STERLING RANCH SKETCH PLAN AMENDMENT & REZONES

LETTER OF INTENT

OCTOBER 2023

Approved Sterling Ranch Sketch Plan

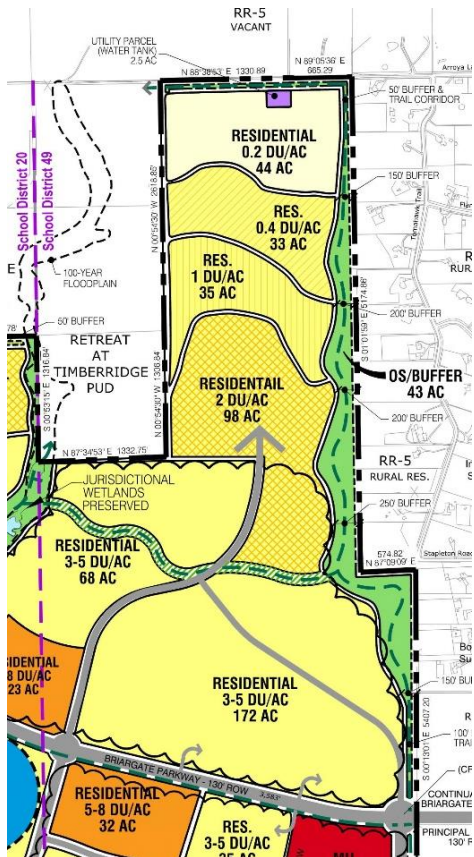
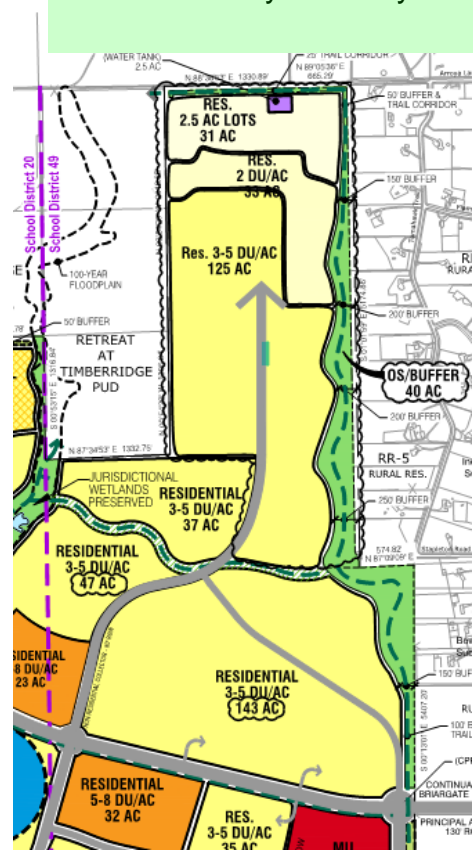
Excellent clarity - thank you

Current Zoning

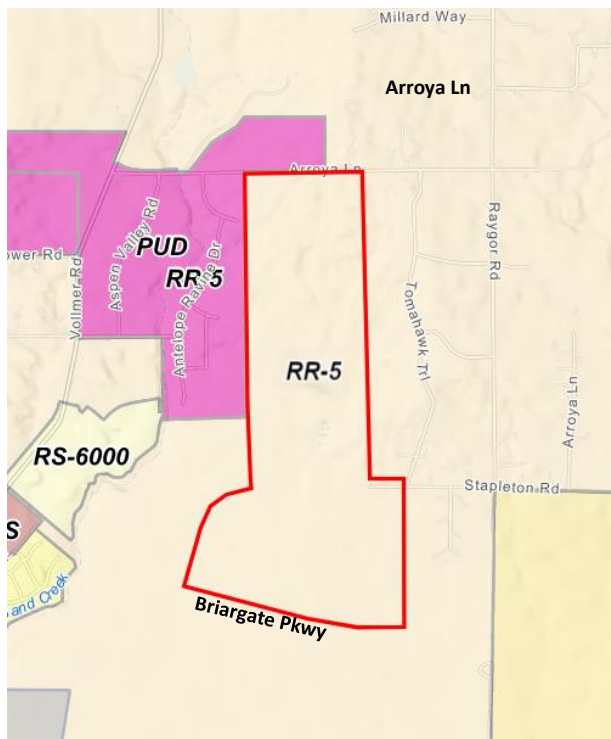
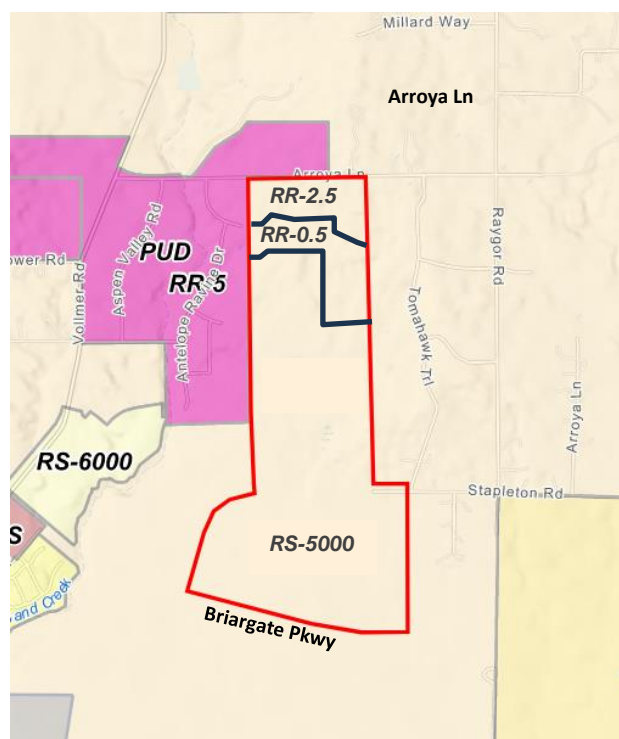
Rezones ← **Rezones (Map Amendment)**
